Subject: Product Change Notification Change on UTO coupling gasket and receptacle housing

All 0, 1, 7 type receptacles of the UT0/UT0W series are affected. Product part numbers remain the same.

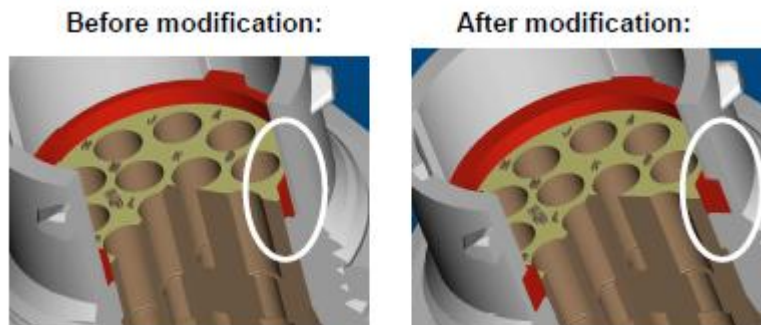
Description of Change: A groove is added in the UTO receptacle, and the design of the coupling gasket is changed

Reason for Change: Avoid the dislodging of the seal during shipment and to improve the dynamic sealing.
